MINOR DESIGN UPDATES UNDER CONSIDERATION FOR FINAL DESIGN

TxDOT is considering design updates to the plans you see on the schematic roll plots. Design updates will be made after this Public Hearing in consideration of public comments received and included in the FEIS. The information below details a change under consideration for the project's final design.

NEW EAST-WEST CONNECTION

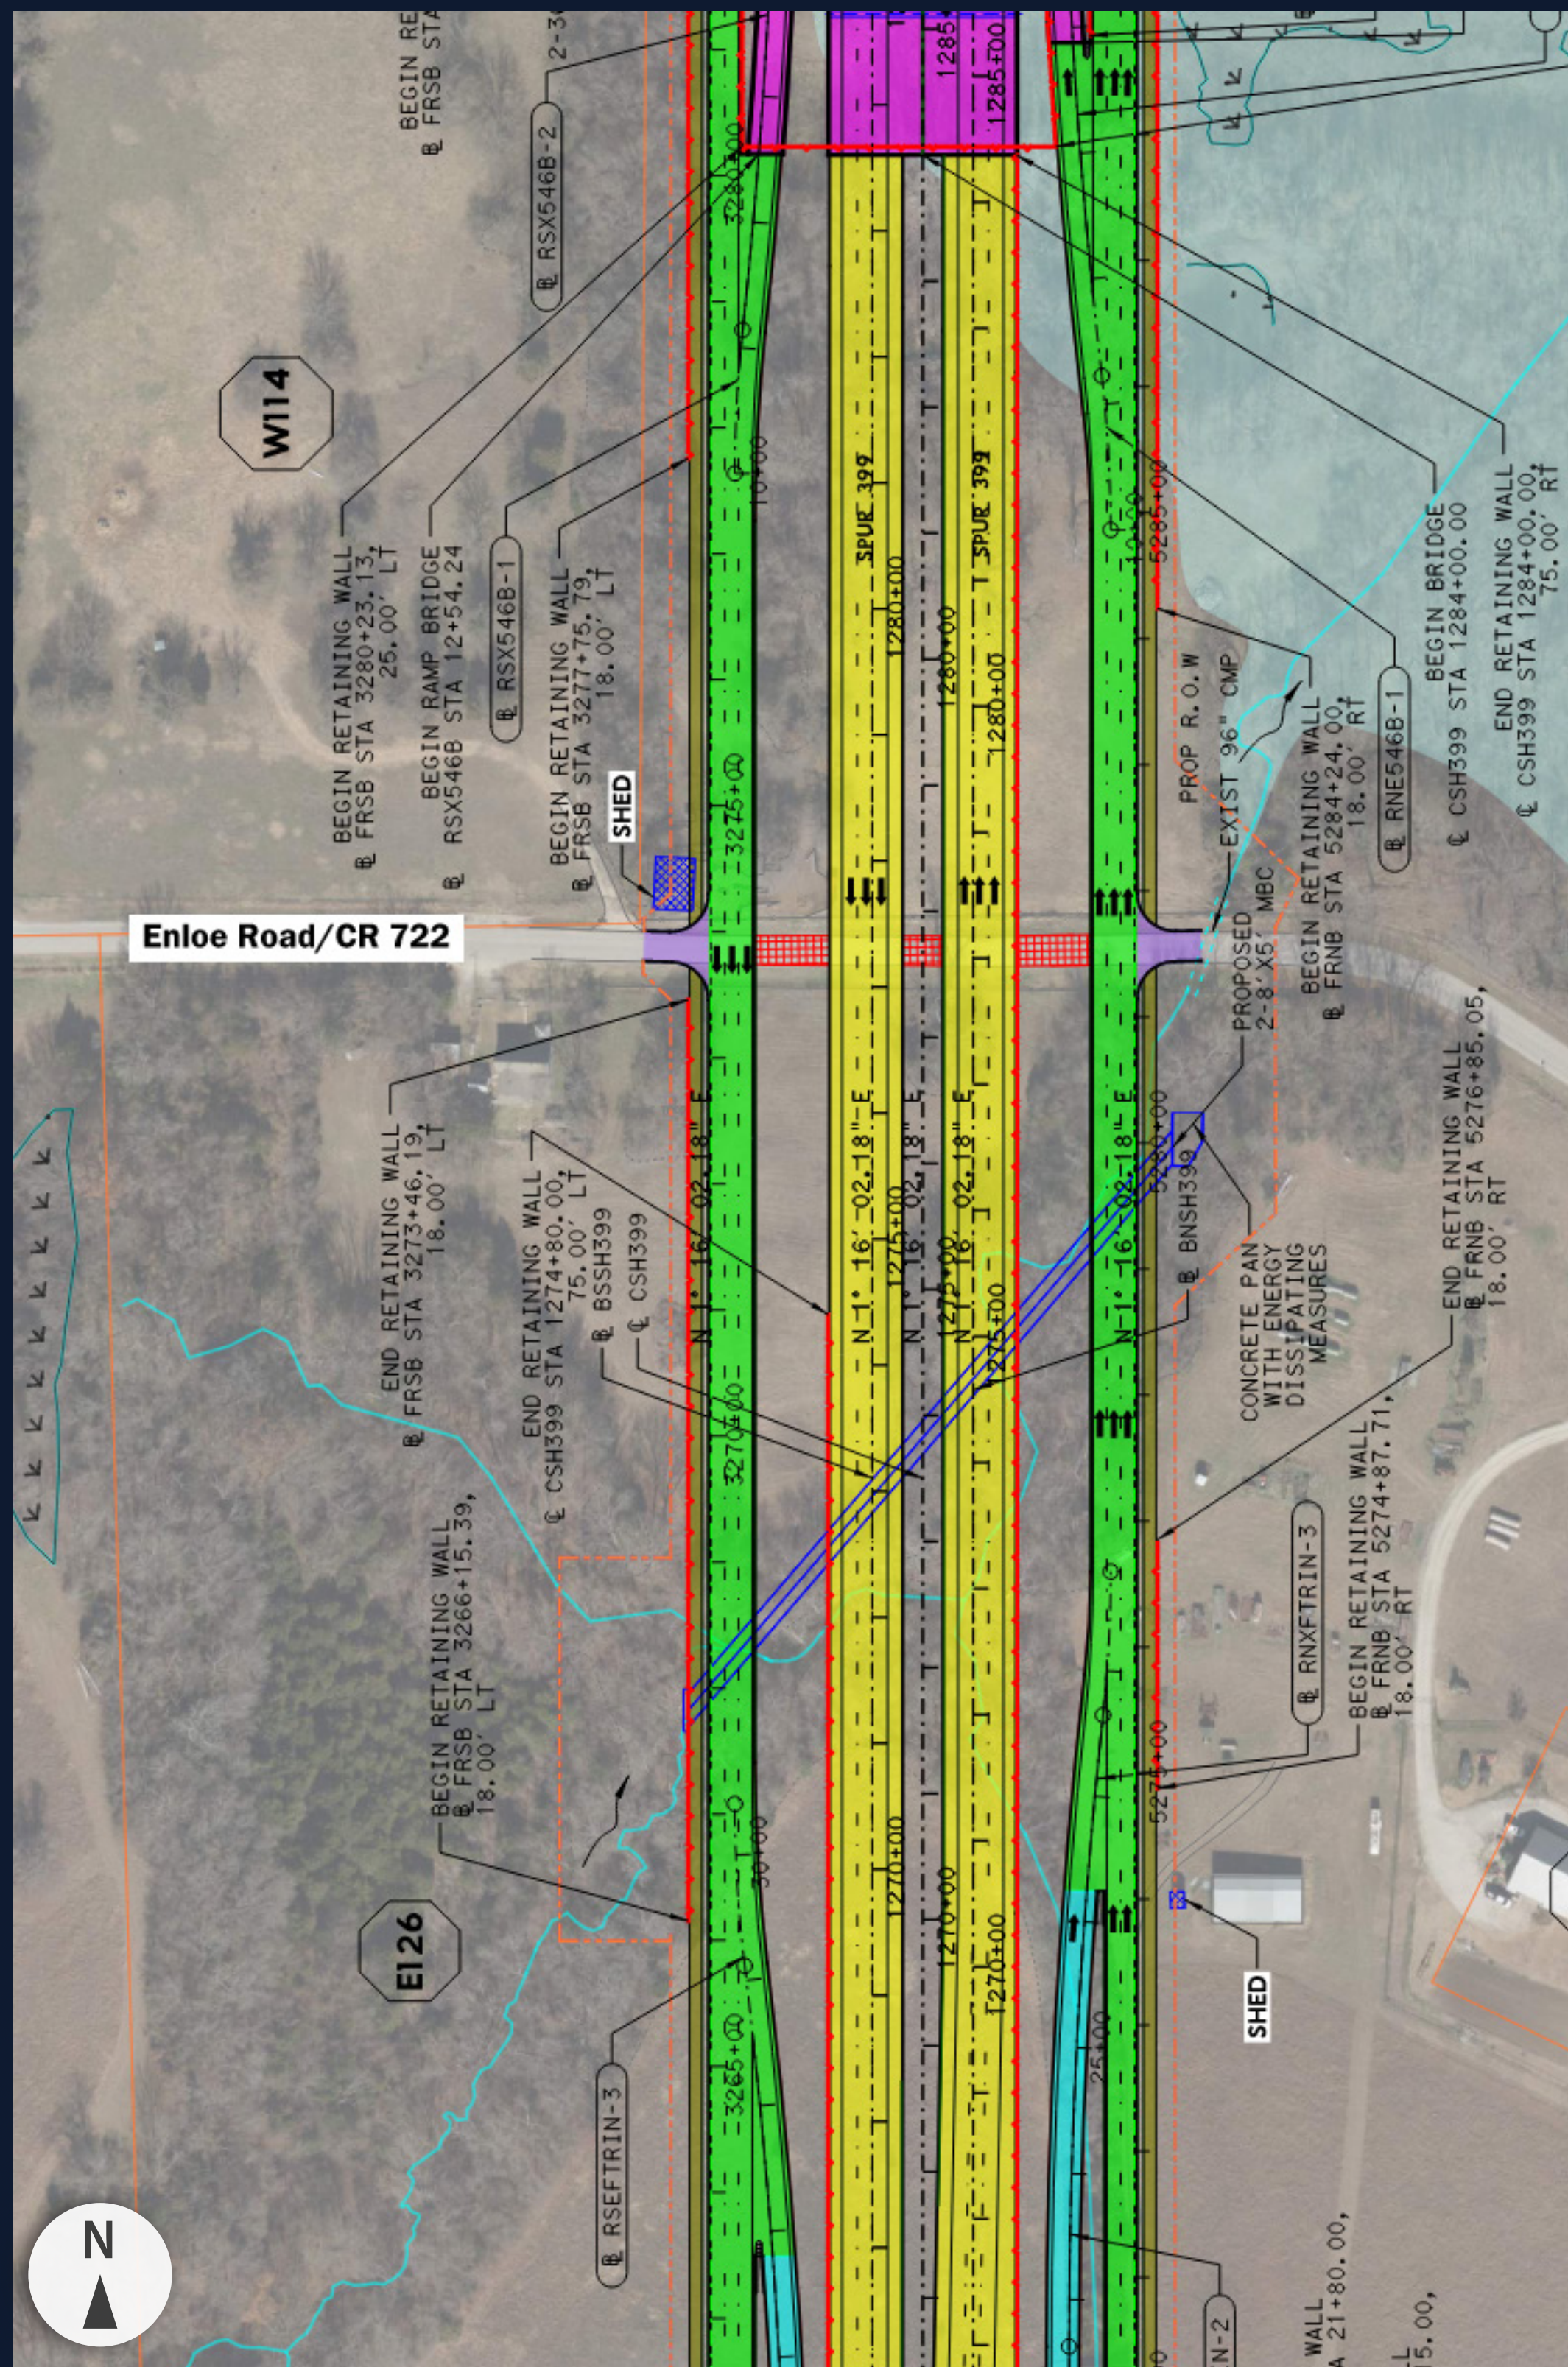
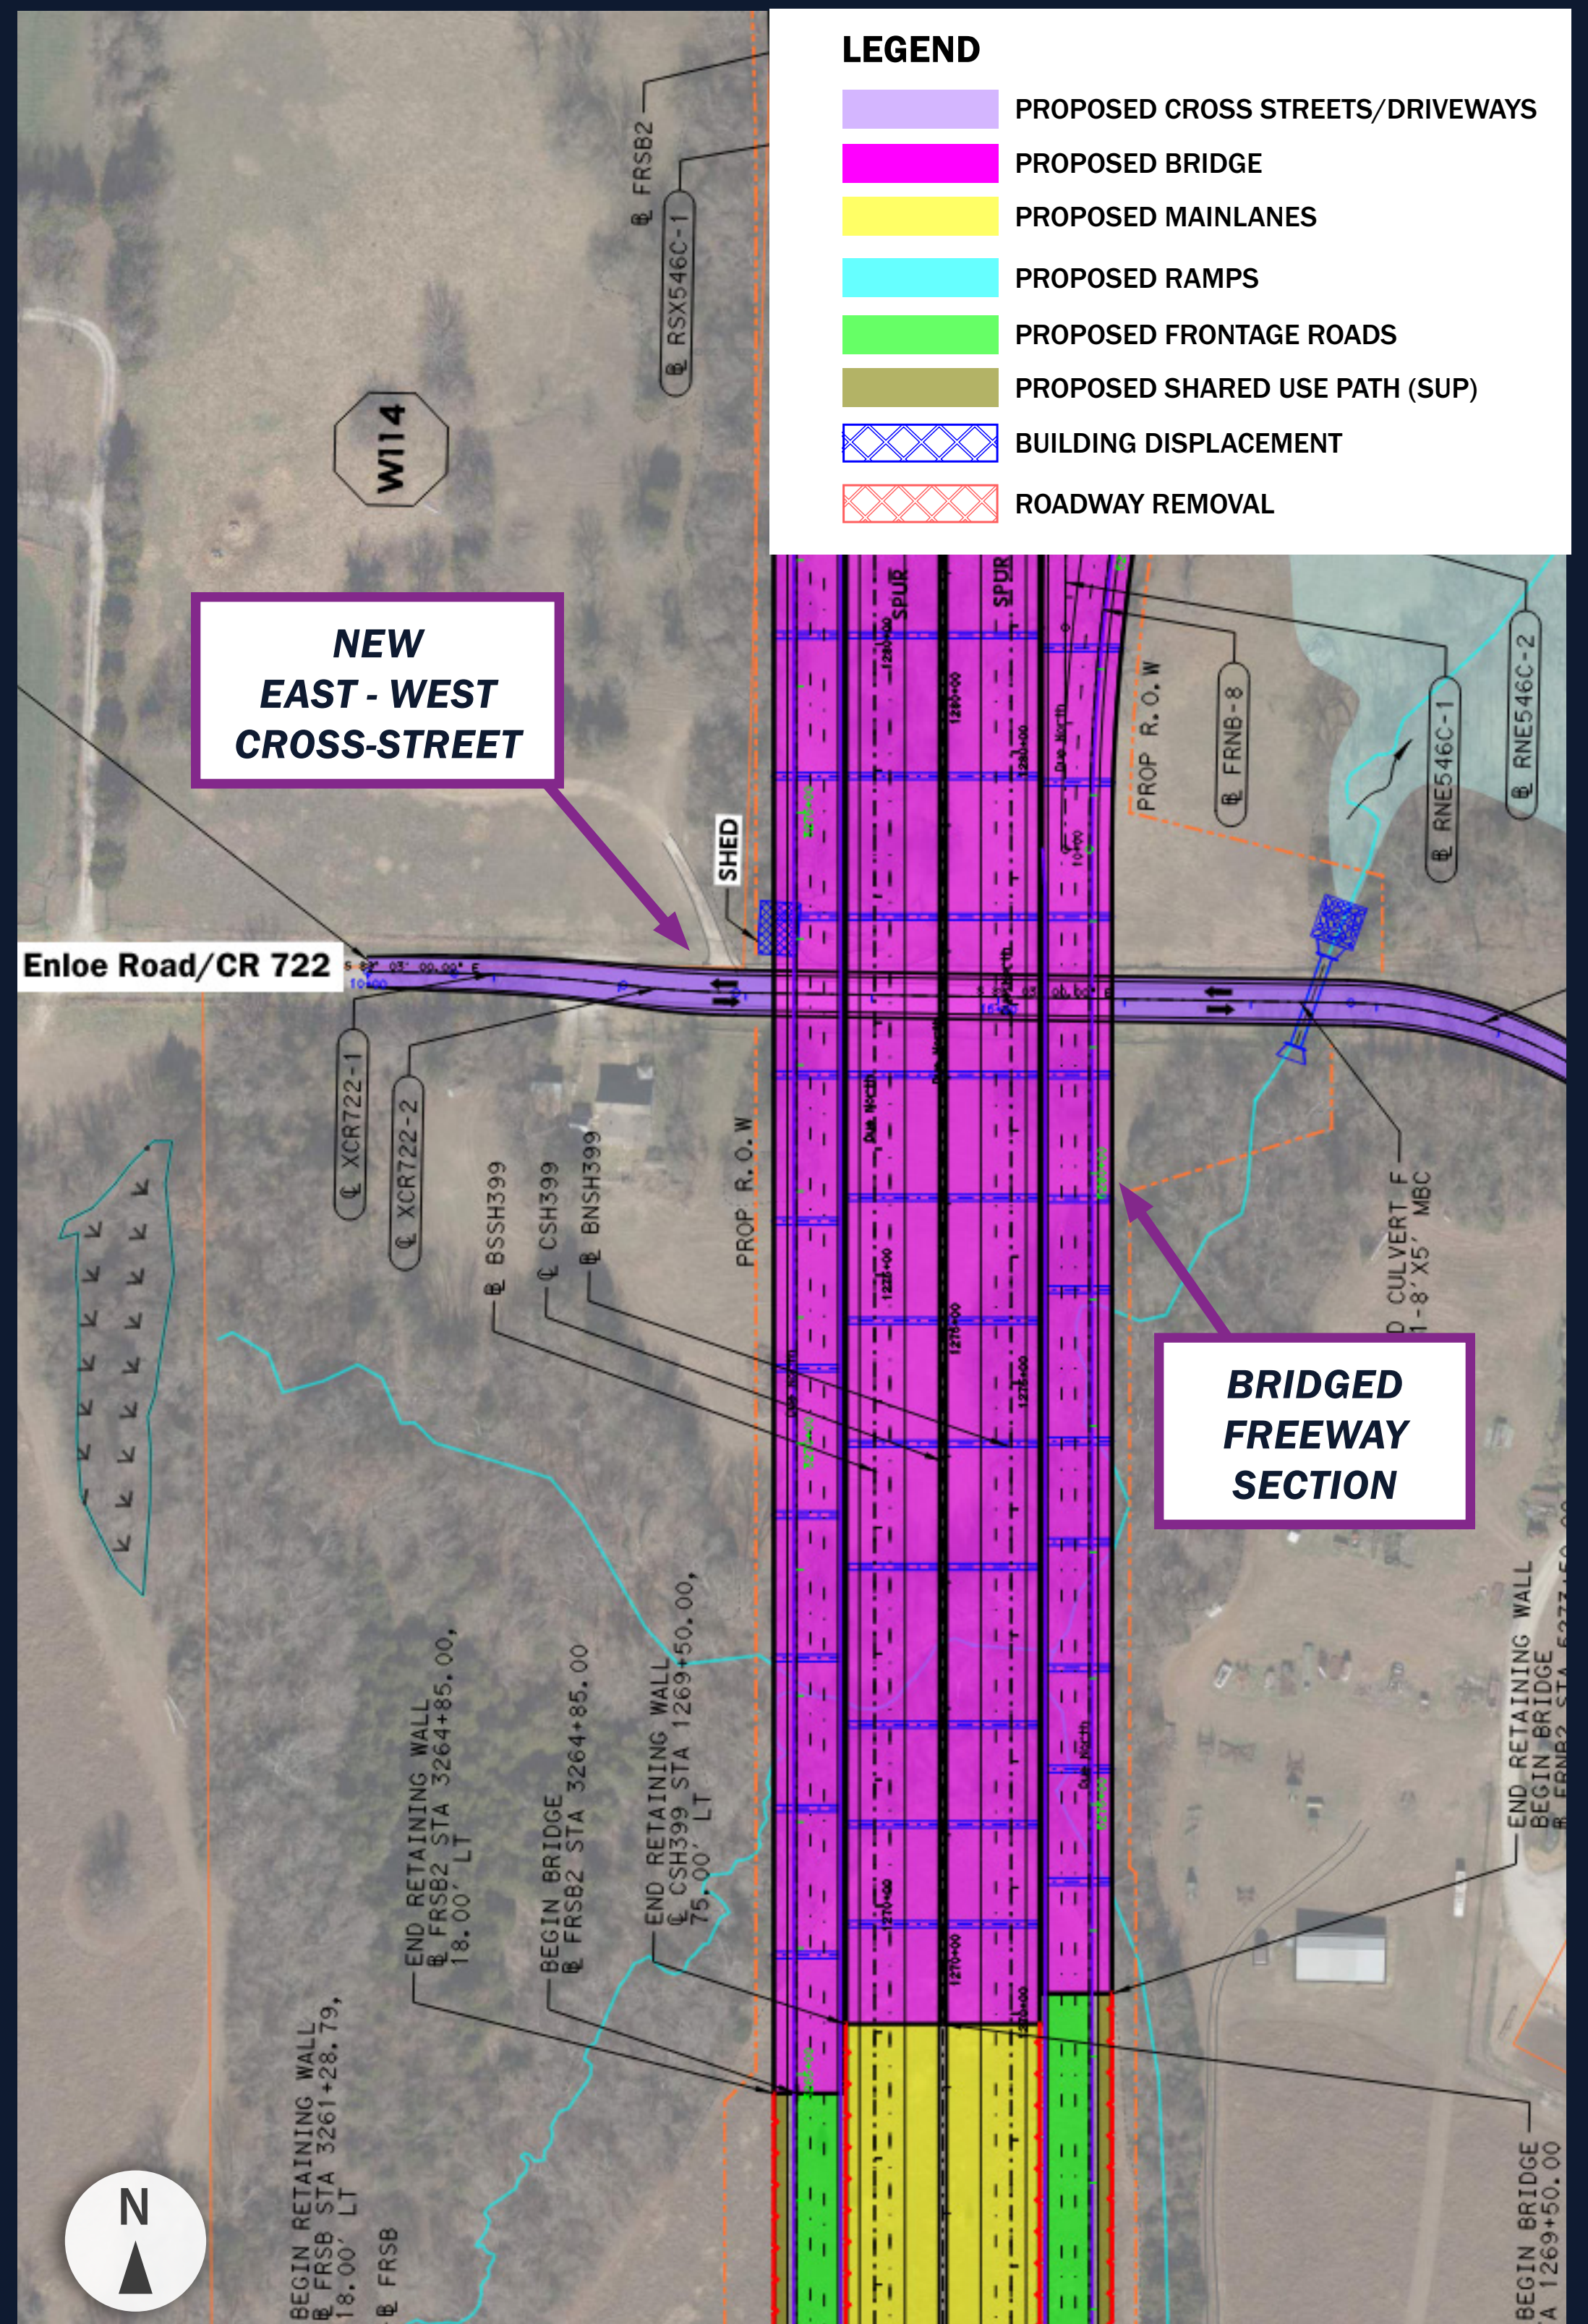
In response to public comments expressing concern over potential impacts to the Enloe family farm property (shown left), TxDOT performed intensive surveys and archaeological shovel tests as an added measure of due diligence. Findings indicated that the Enloe Property did not meet the requirements for inclusion in the National Register of Historic Places.

To accommodate requests from the Enloe family for improved east-west connectivity, TxDOT extended the elevated section of freeway to provide a crossing below the freeway.
